City of Issaquah
Development Services Department (DSD)
Site Development Permit

NOTICE OF DECISION

SUBJECT: Site Development Permit for Rowley Extended Stay Hotel, Rowley Properties
Urban Village

Number: PLN12-00069

Conceptual redesign of Hyla Ave NW for consistency with adopted Local Street Standards.

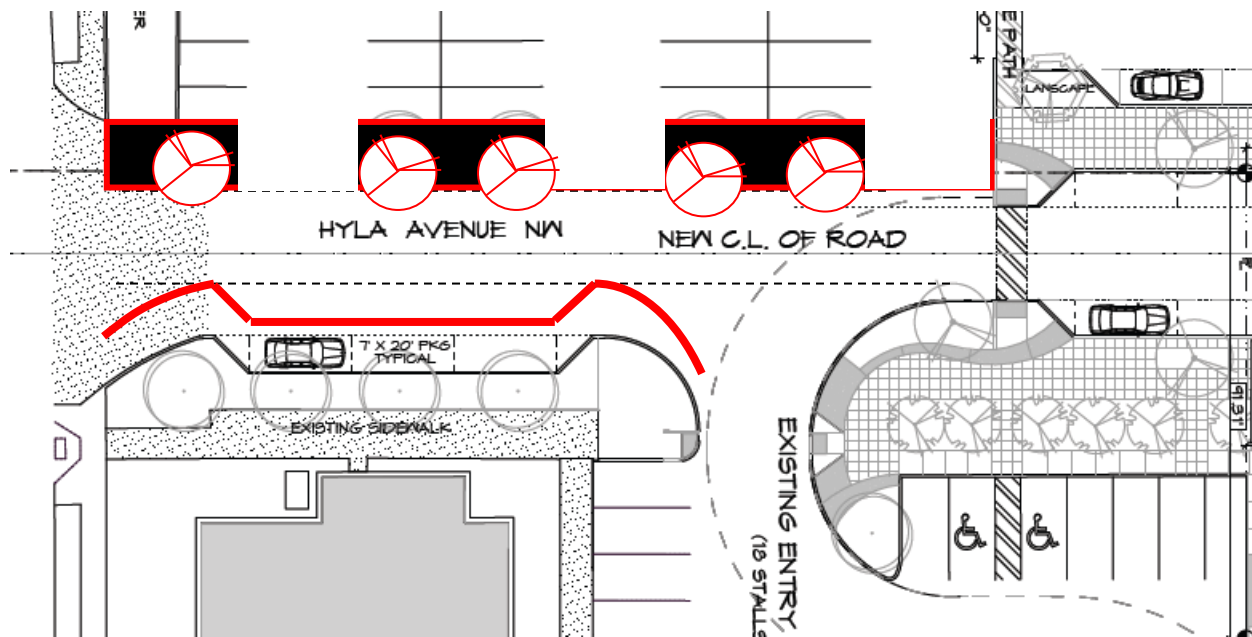
The proposed street dimensions and landscape treatment along the length of new Hyla Ave NW are not consistent. The south section of the street, where Hyla Ave NW comes off NW Gilman Blvd, does not match the street section to the north of the hotel vehicular entry drive and no pedestrian facilities are provided on the west side of the street. The vehicle lane width is 15 feet coming off NW Gilman Blvd, wider than the 9-foot section proposed north of the hotel vehicular entry drive, even though this portion of the road is being rebuilt. The vehicle lane width for “Local Streets” is 10 feet for commercial uses. The wider vehicle lane and street section coming off the main intersection from NW Gilman Blvd could allow for higher vehicle speeds and may not be conducive or welcoming to pedestrian and bike access. Since both sides of the street are being rebuilt, curbs must be extended out, resulting in travel lane widths consistent with the Local Street standard and sidewalks on both sides as conceptually shown below. **[Condition10]** Proposed dimensions have some variability, such as travel lanes widths are 9 ft for residential, 10 ft for commercial, sidewalks of 6-10 ft each side, and planter widths of 4-8 ft both sides. As travel lanes are the most difficult or expensive to revise with future permits, the wider vehicle lane may be necessary now to accommodate future commercial development to the north of the hotels. With construction permits, the applicant will work with the Designated Official to determine the specific appropriate widths for each component. The revision will remove some parking however, minor changes to and restriping of the existing west parking lot’s drive aisle could provide all lost parking with minimal expense and effort.

In addition, the south street section includes a 7-foot wide planter strip with street trees, while the street section to the north of the hotel vehicular entry drive proposes planter islands versus a continuous planter strip. Hyla Ave NW is one of the major local streets identified on the Master Circulation Plan, and the street dimensions and landscape treatment should be consistent for the portion being constructed at this time. **[Condition11]**

-
- 11 Use a consistent tree type and tree installation along Hyla Ave from Gilman Blvd to Skipper Way.
 - 12 With permits for construction, the applicant should provide further information regarding how as the Project builds out bicycles can comfortably share Hyla Ave NW given planned future development, vehicle volumes and speeds, and considering other bicycle connections or alternative routes.
